WIZARD WORKSHOP ARTICLES

SC502 CAMERA MOUNT

SC 502

TEKTRONIX TYPE SC502 PREVENT TRANSFORMER CORE FROM SHORTING
TO CIRCUIT BOARD RUNS

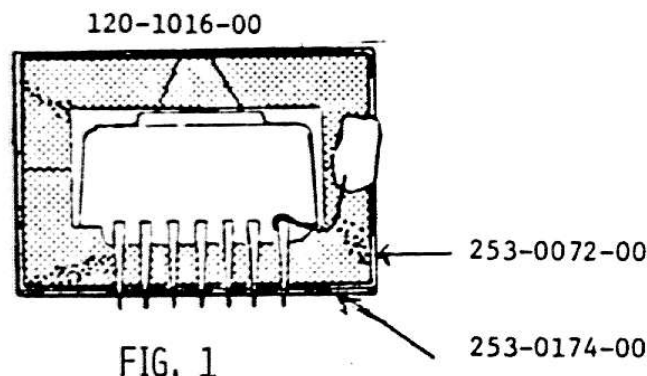
It has been found that the high voltage transformer, P/N 120-1016-00, when assembled to the circuit board has had very thin tape placed between the board and the transformer core, which in turn has caused instances where the core has been shorting to the circuit board runs. An internal change has been made to correct this. Refer to Fig. 1. The description of the change consists of adding a layer of .003 press tape (P/N 253-0072-00) to T800 High Voltage transformer. To insure reliability of the instrument they have increased the coverage and total thickness of the insulating tape. Poly-double sided tape (253-0174-00) will still be used, but applied on top of the new tape as shown in Figure 1. It is recommended that any time the transformer circuitry is worked on, this transformer should be removed and this additional tape be installed on the transformer core to prevent future shorting. Also, any transformers in stock should be checked to see if this additional tape is on the bottom of the transformer core. If it is found to be missing it is recommended that you install this additional tape.
